MEMORANDUM

Date:	April 15, 2026	GTS: 240903
From:	GTS	
To:	City of Beaumont	
Cc:	Chambers Group	
Subject:	Sight Distance and Swept Path Analysis – Beaumont City Yard Project

This Memorandum contains a review of the following items in the site design for the site's four entrance/exit driveways:

Exhibit 1.2. Sight distance triangles: north driveway

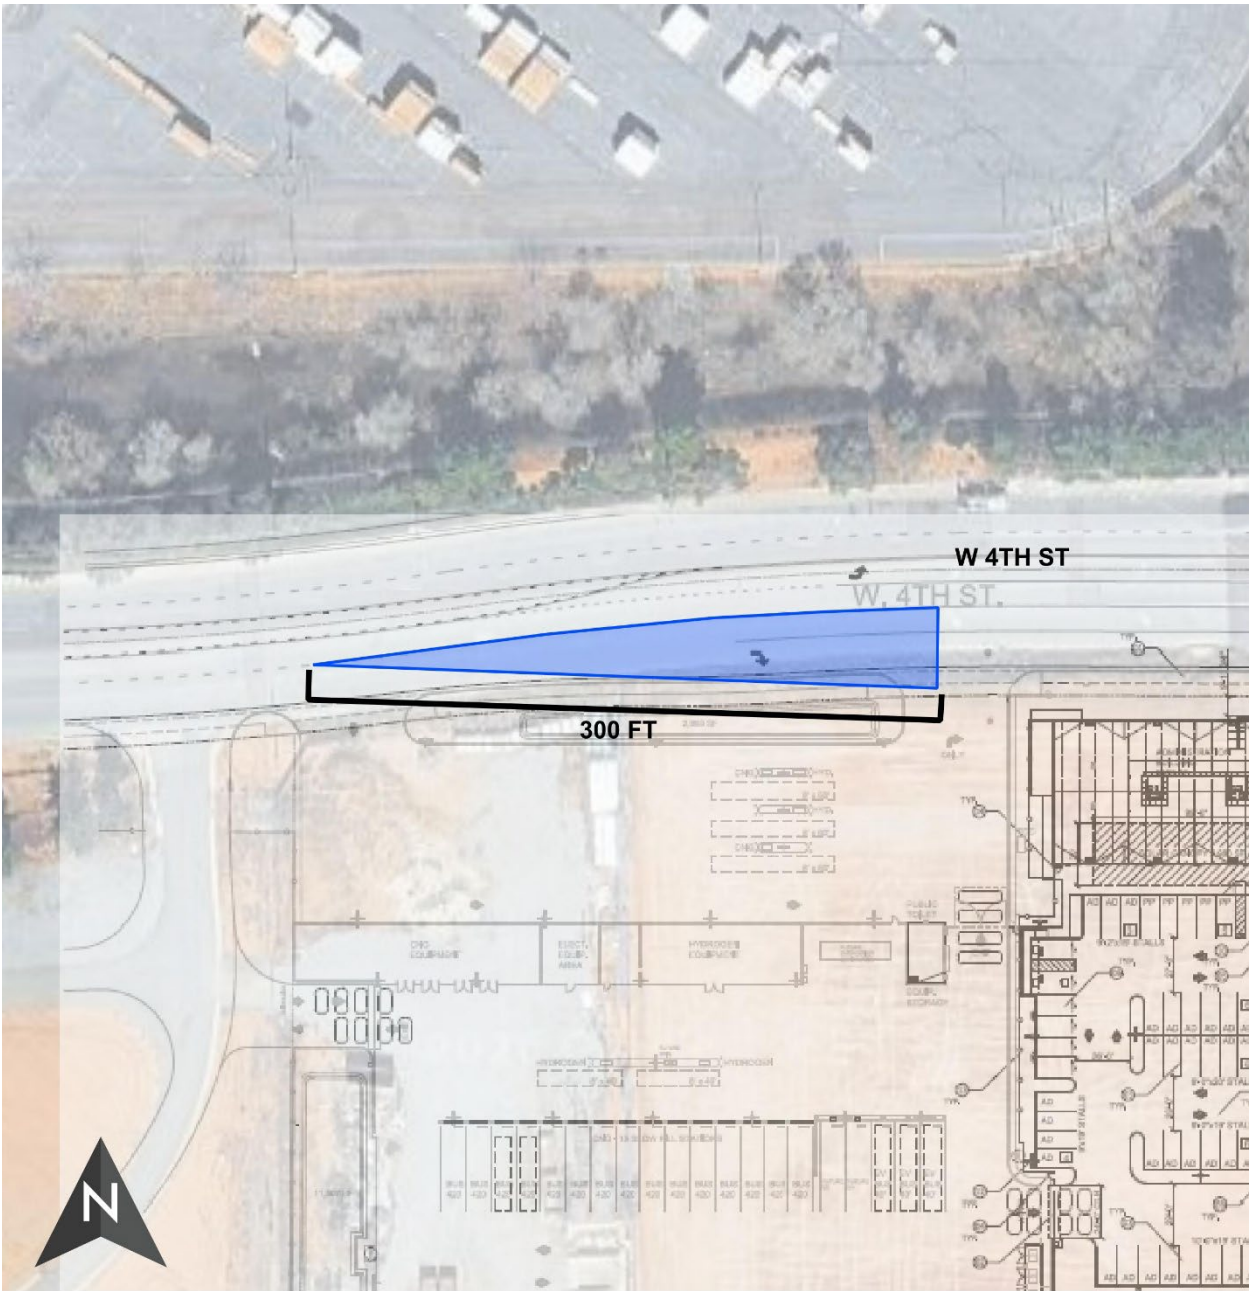
Driveway	Posted speed limit	Stopping sight distance	Direction	Result	Exhibits
North (W 4 th St.)	40 mph	300 feet	Looking left (west)	Achieved	1.2, 1.6
East (Veile Ave.)	35 mph	250 feet	Looking left (north)	Utility poles may block the view for a driver stopped behind the STOP bar. However, prudent drivers typically roll forward to enhance their view after coming to an initial stop. For a driver pulled forward (but not encroaching on the travel lane), the sight distance is achieved.	1.3, 1.7, 1.8
			Looking right (south)	Achieved	
Southeast (Veile Ave.)	35 mph	250 feet	Looking left (north)	Achieved	1.4, 1.9, 1.10
			Looking right (south)	Parked vehicles may block the view. Red curbing is recommended (see Section 1.1: Recommendations).	
West (WWTP access road)	5 mph	50 feet	Looking left (south)	Achieved	1.5, 1.11
			Looking right (north)	Achieved

Exhibit 1.4. Sight distance triangles: southeast driveway

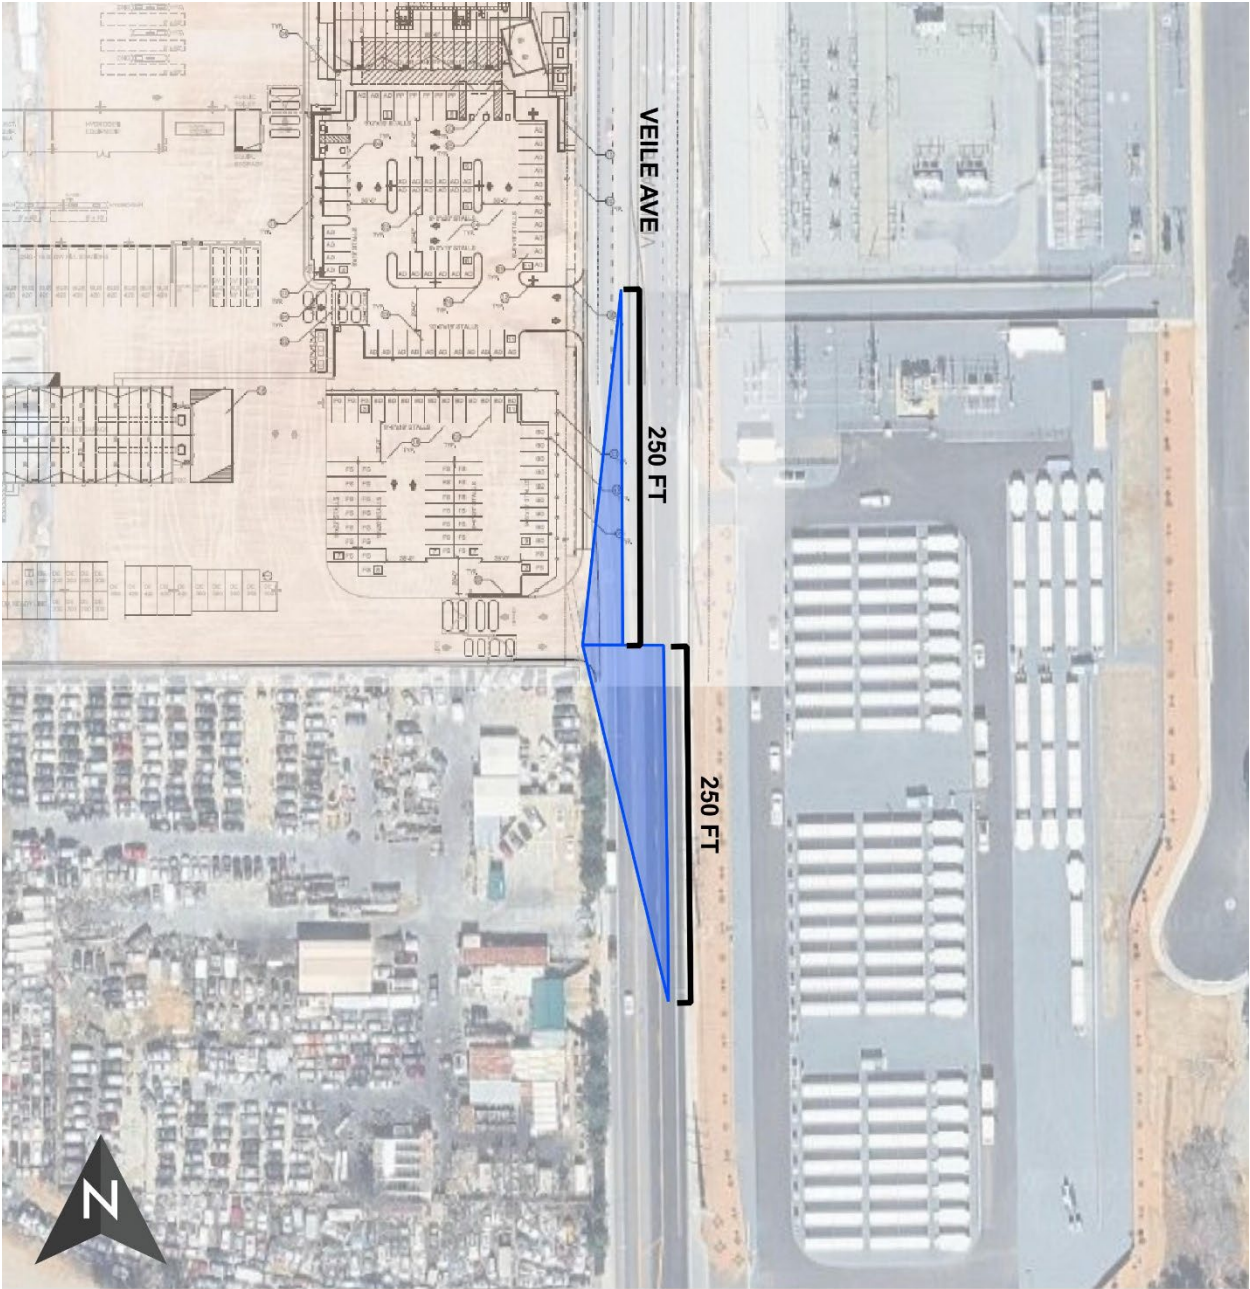
- At the southeast driveway, parked cars along Veile Ave to the south of the site may obstruct an exiting driver's view. Red curbing is recommended along the west side of Veile Ave from the site's southeast driveway southward for at least 100 feet and possibly as far as the driveway belonging to the adjacent site to the south. The exact length of red curb needed can be calculated after construction.

Exhibit 2.2

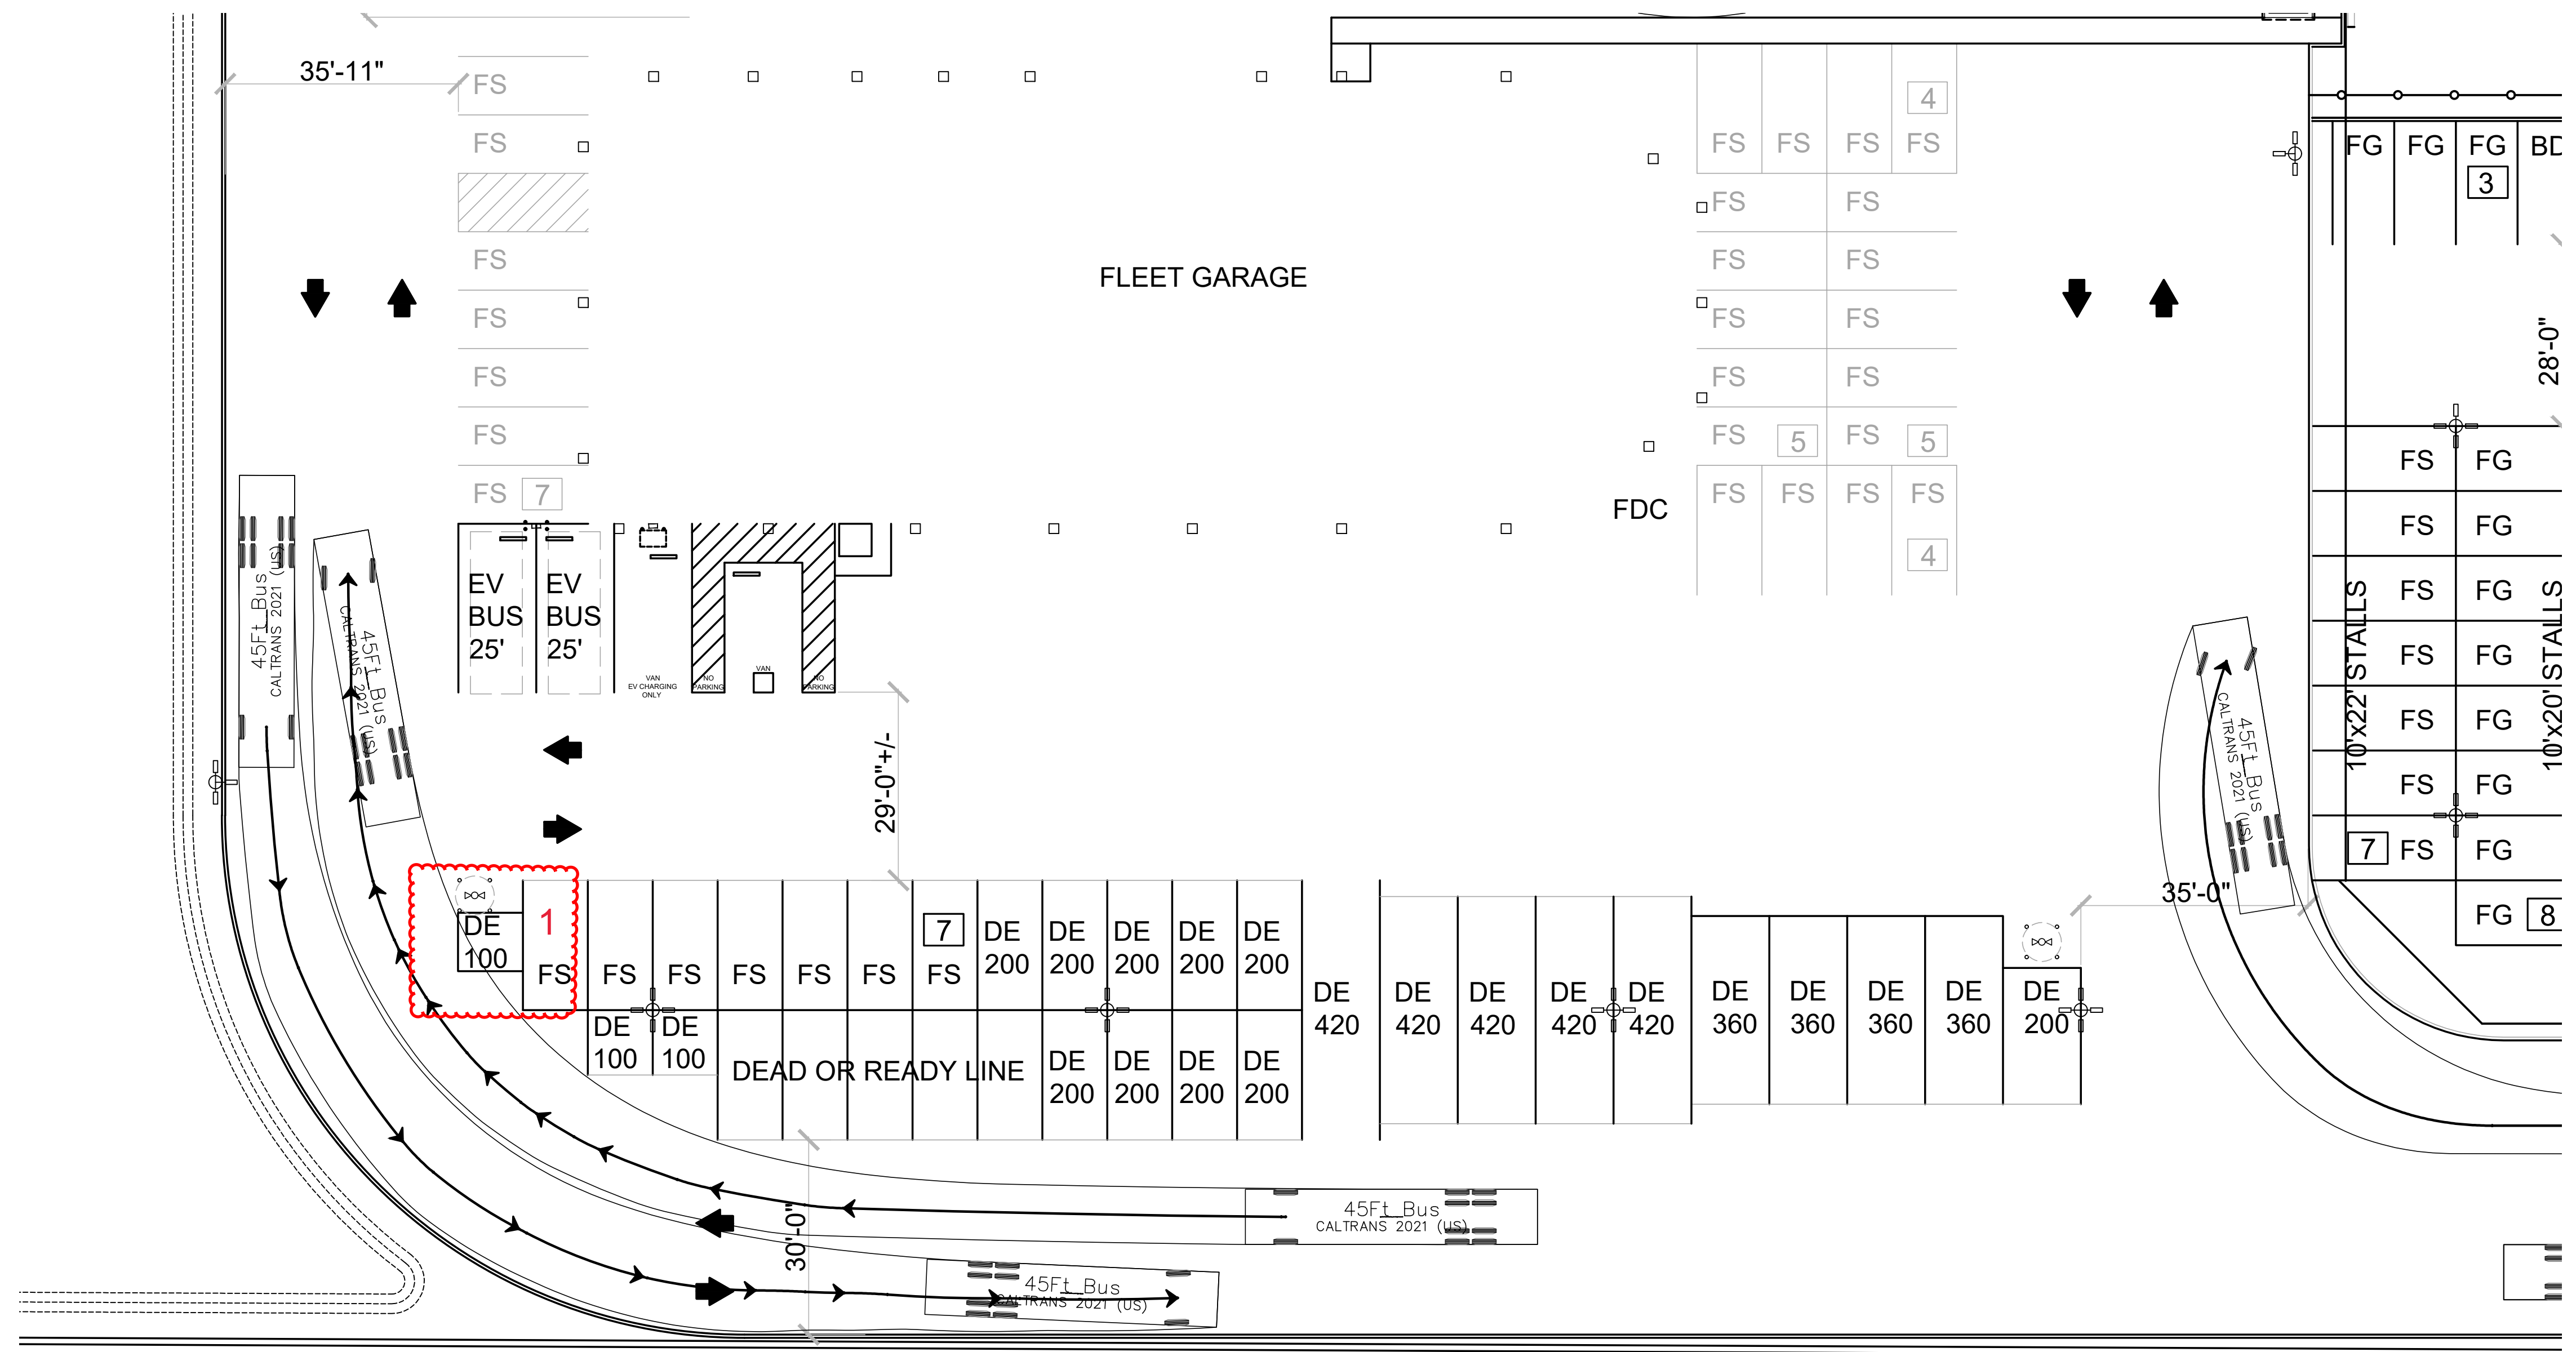
1. At the southwest corner of the site, there may be a conflict between two vehicles moving in opposite directions near to the space labeled “DE 100” (see Exhibit 2.2).

Exhibit 2.3

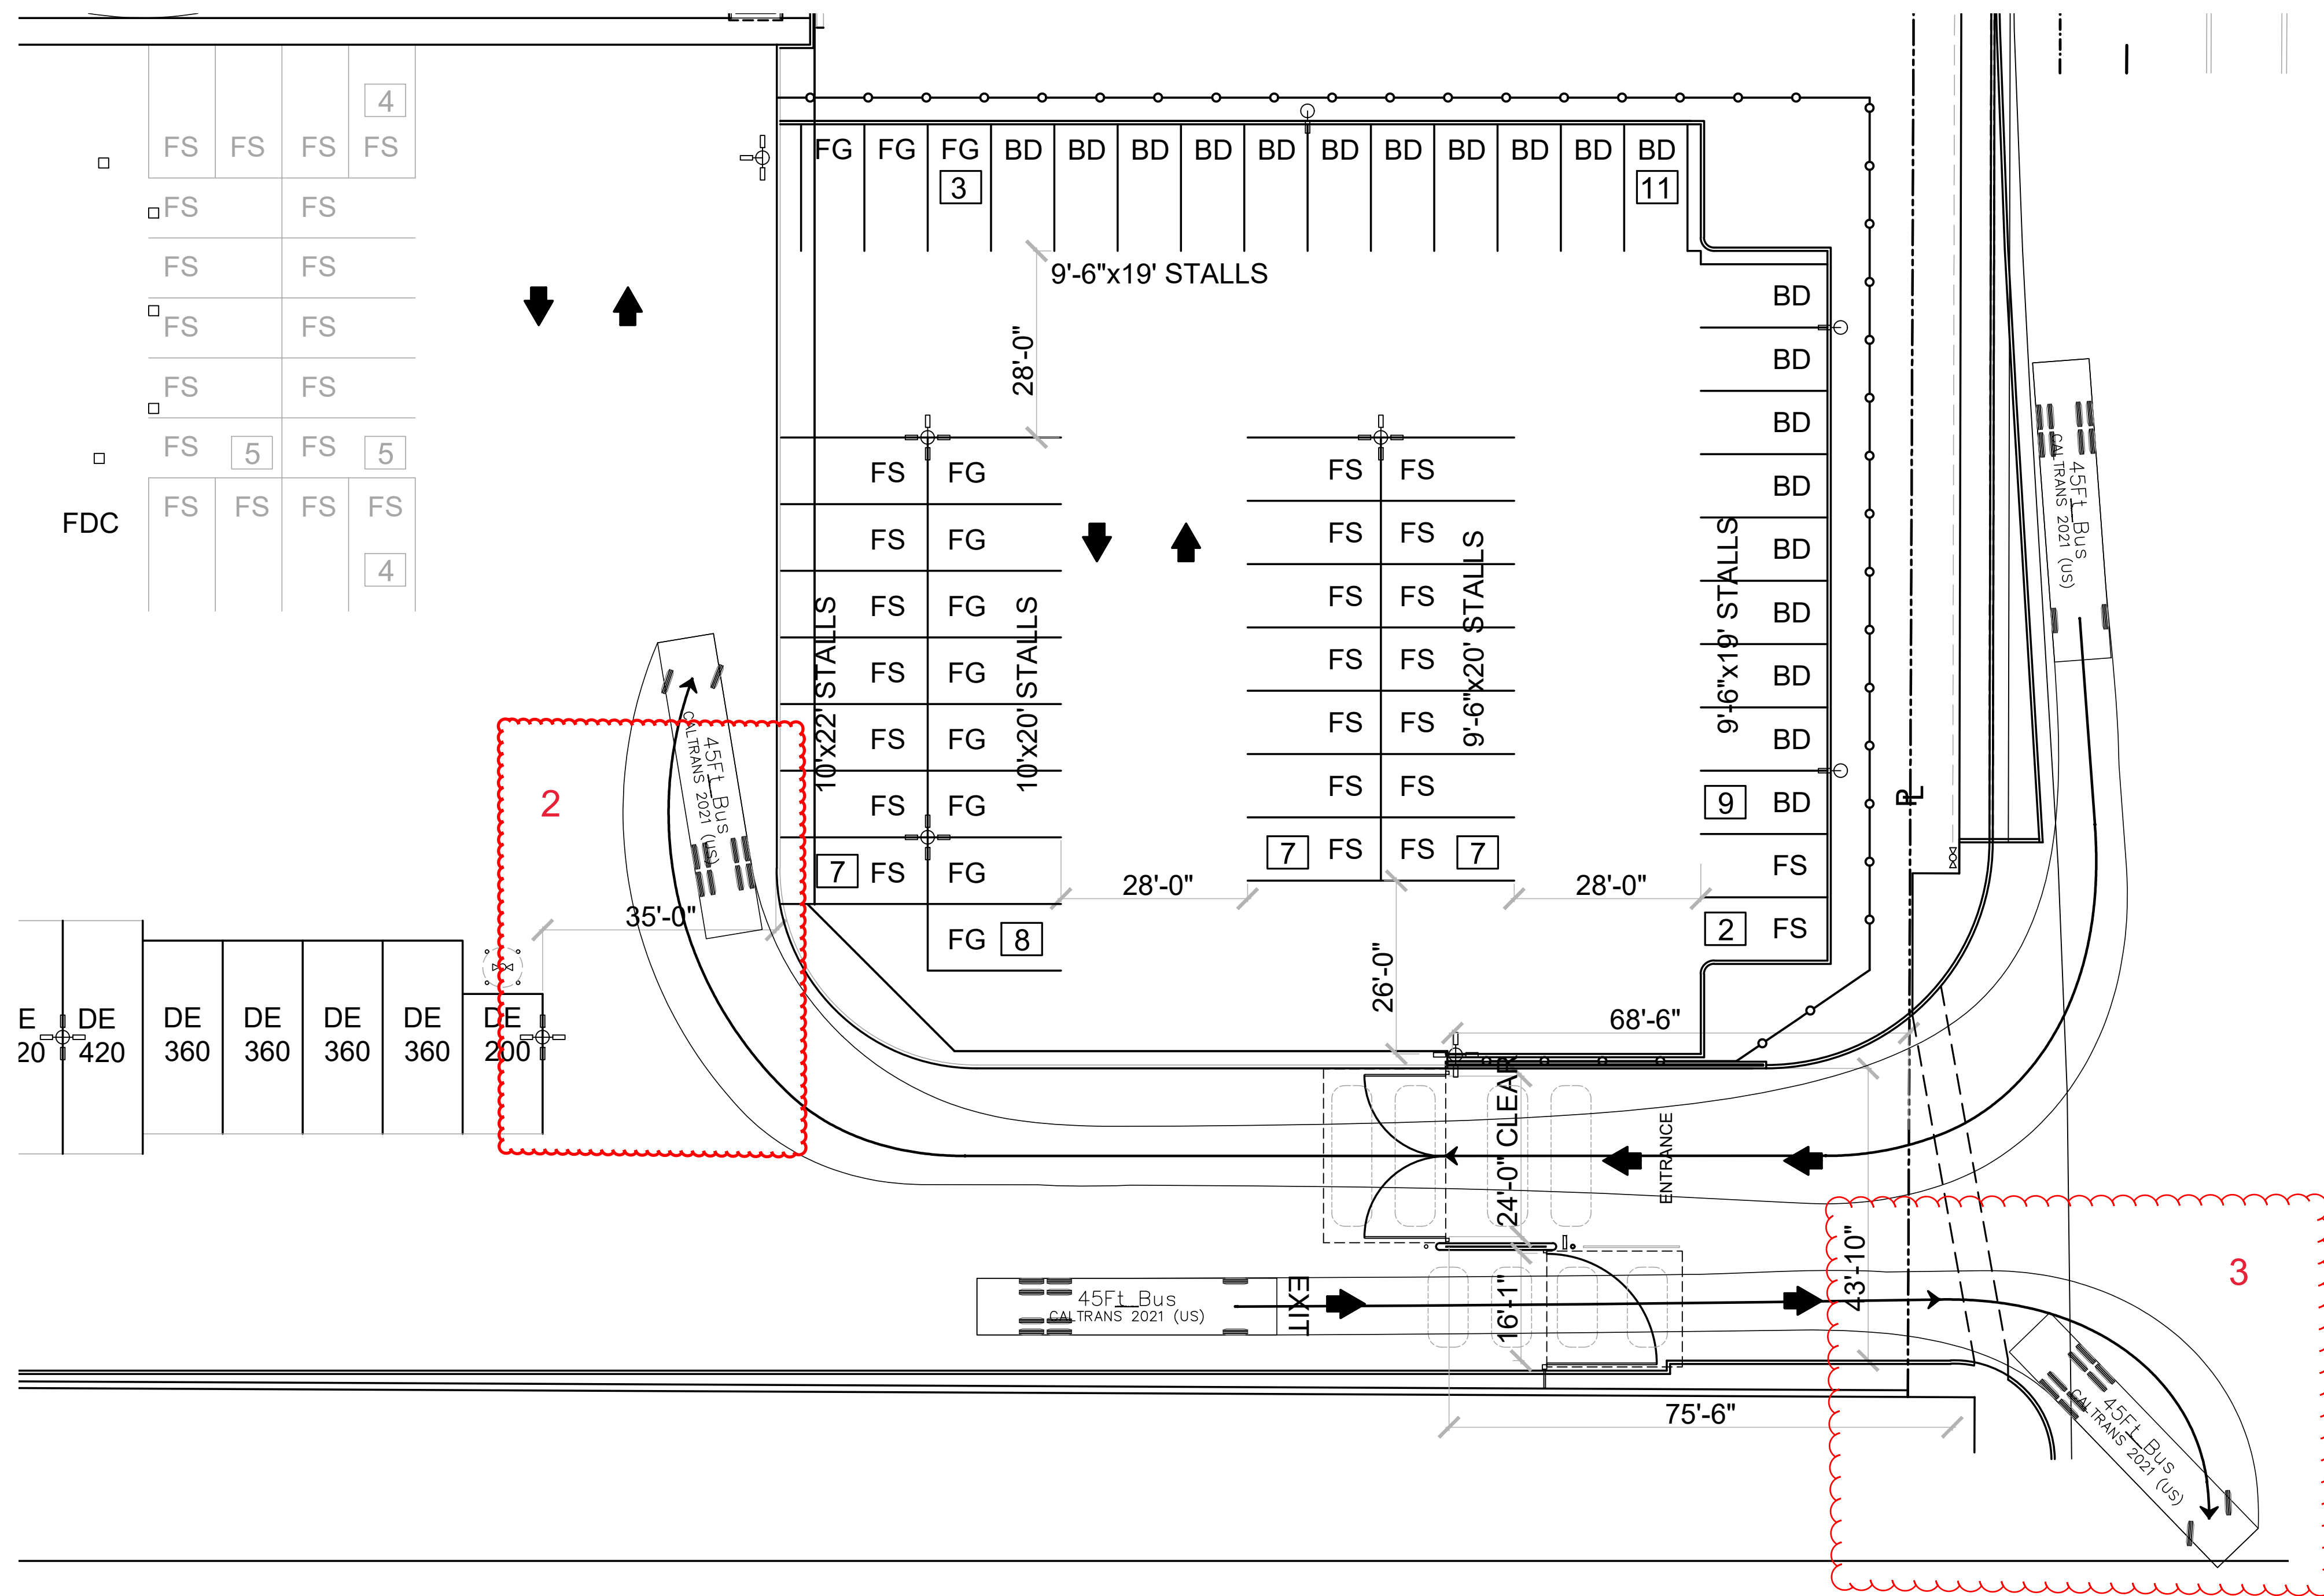
2. Near the south central portion of the site, there may be a conflict between two vehicles moving in opposite directions near to the space labeled “DE 200” (see Exhibit 2.3).

3. At the southeast driveway, a vehicle exiting and turning right (southbound) could encroach into the center turn lane on Veile Ave (see Exhibit 2.3).
